VILLAGE OF LOMBARD
REQUEST FOR BOARD OF TRUSTEES ACTION
For Inclusion on Board Agenda

TO: PRESIDENT AND BOARD OF TRUSTEES
FROM: David A. Hulseberg, Village Manager *DAH*
DATE: November 5, 2009 (B of T) Date: November 19, 2009
TITLE: ZBA 09-10: 418 W. Wilson Avenue
SUBMITTED BY: Department of Community Development *WJ*

SUBJECT: ZBA 09-10; 418 W. Wilson Avenue

Attachment B

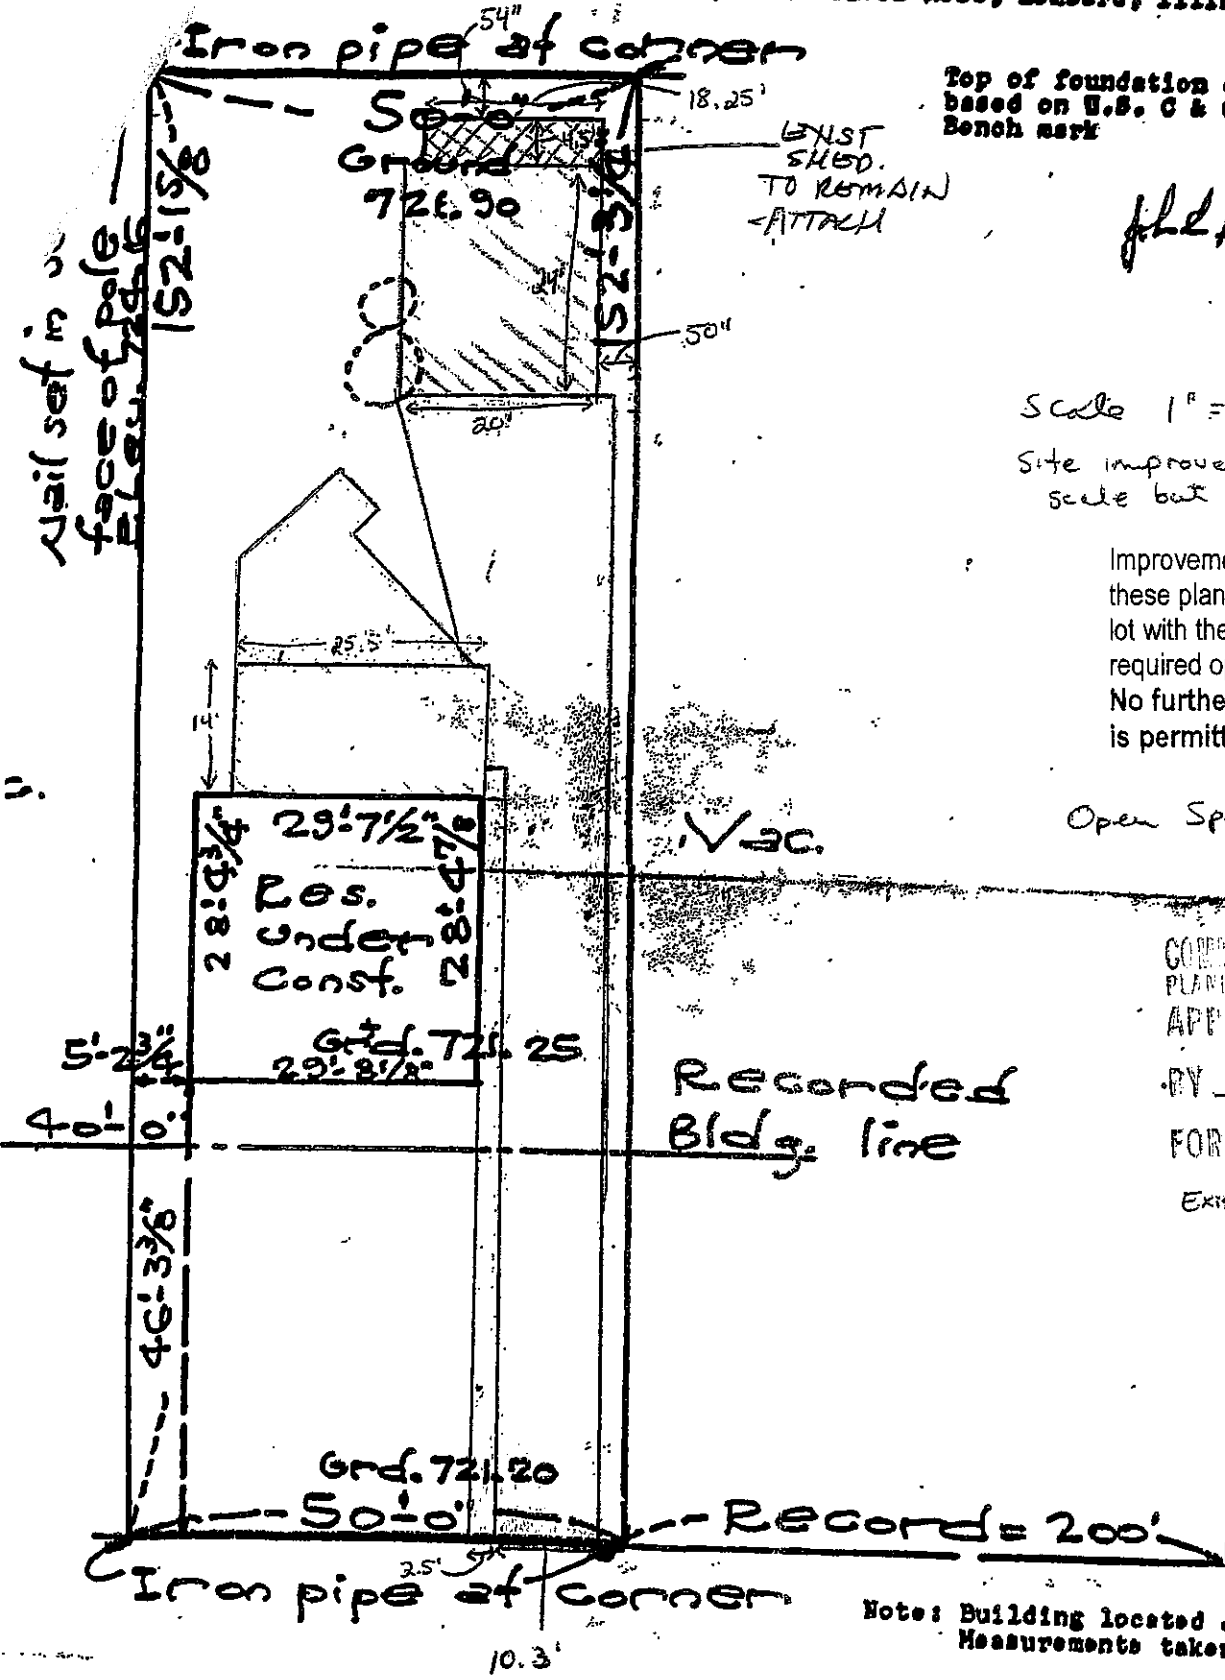
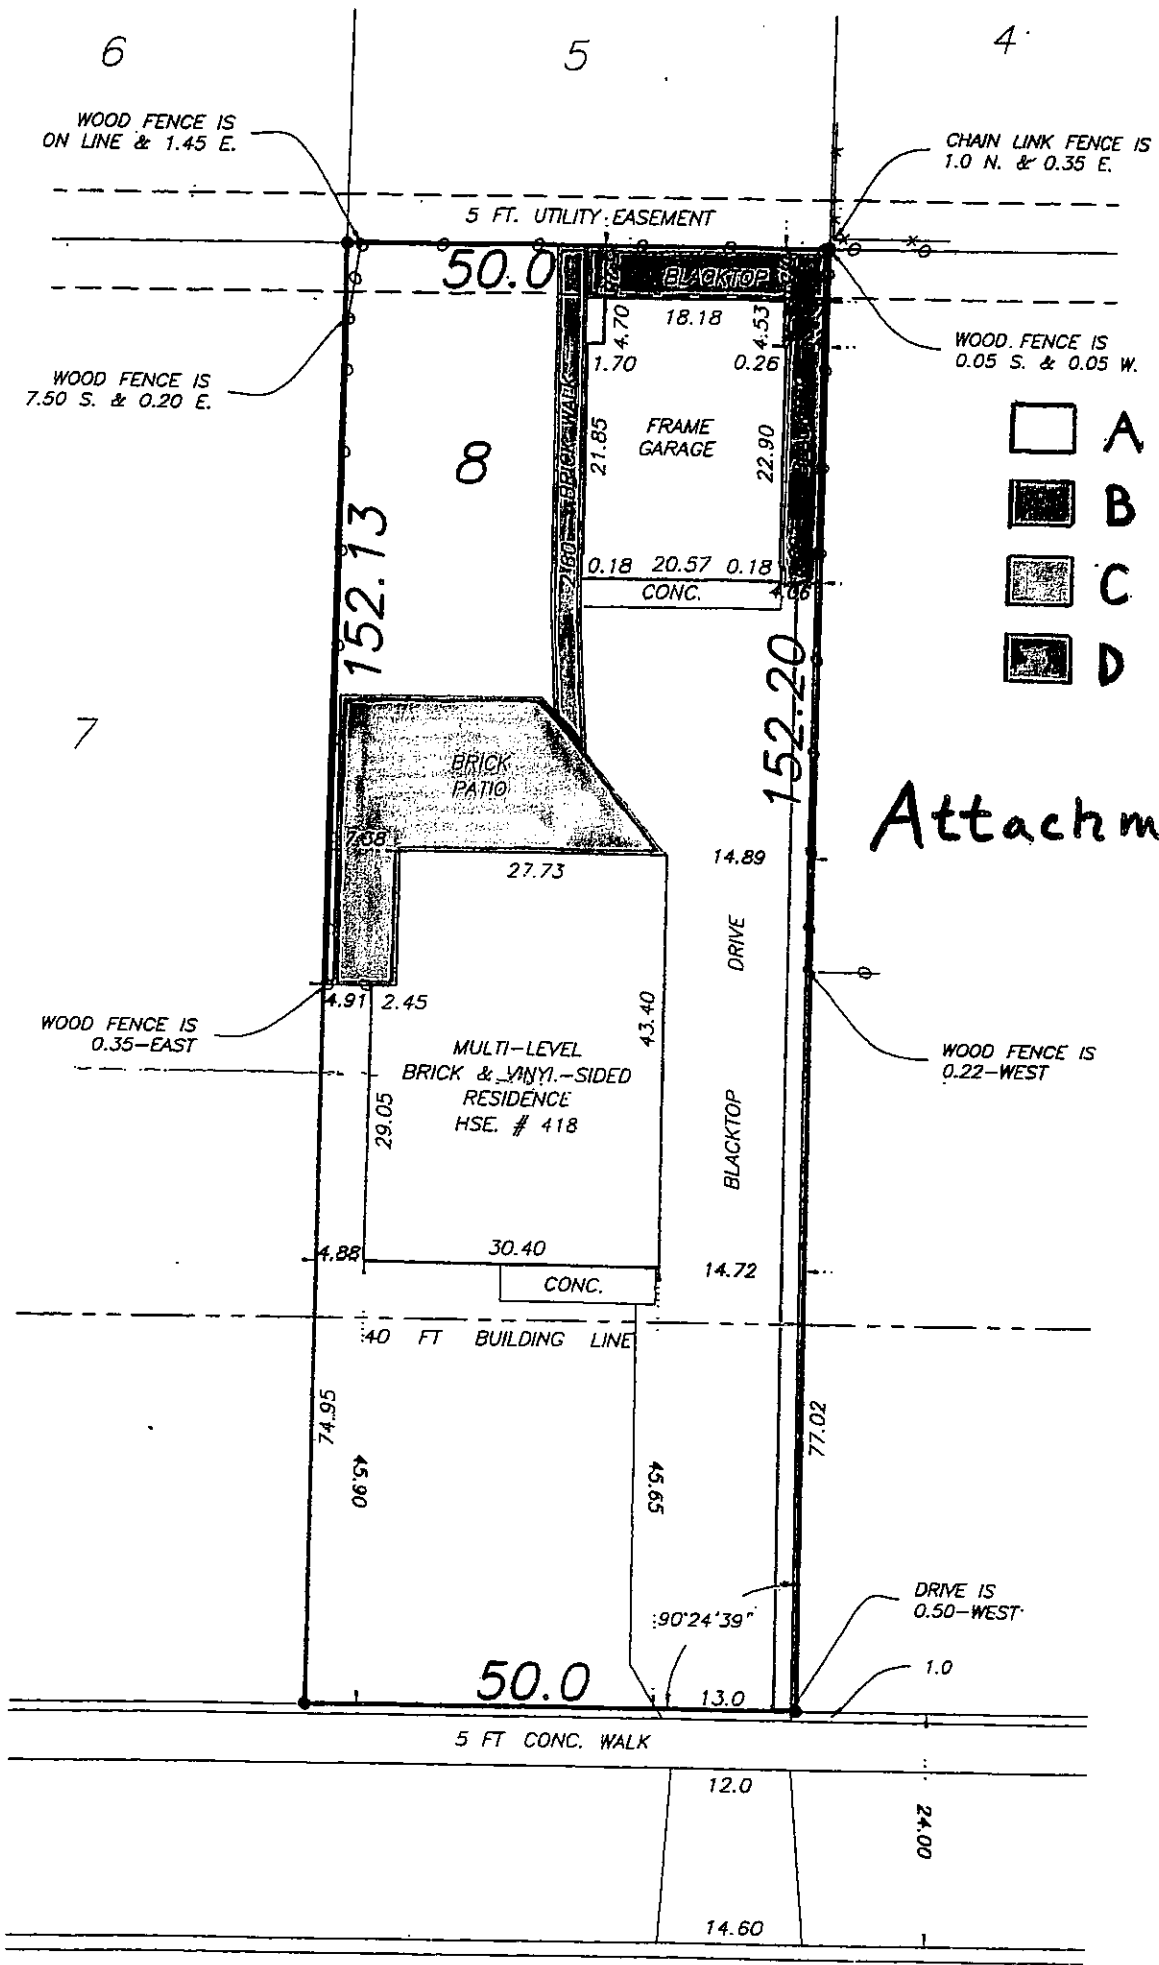
On June 4, 2008, a permit was issued for a garage to replace one that was destroyed by fire. The garage was to be built on the existing concrete slab. Attachment A is an aerial photograph from 2006 that shows these improvements. These site improvements were drawn on a plat of survey and were calculated by staff as occupying 3,779 square feet of the zoning lot. The garage permit was issued with a sticker which indicated: "Improvements shown on these plans will leave the lot with the minimum 50% required open space. No further lot coverage is permitted." For accuracy, the permit also indicated: "Open Space at 50.3%." (See Attachment B.)

Upon an inspection of the lot by Building Division staff, it was discovered that additional impervious surfaces had been constructed which were not depicted on any of the permit applications. (See Attachment C.) These surfaces consist of:

- A. A two and one half foot strip of asphalt located along the eastern property line
- B. Asphalt paving behind and to the east of the garage
- C. A brick paver deck occupying the area to the rear and west of the residence
- D. A brick walkway from the garage to the deck.
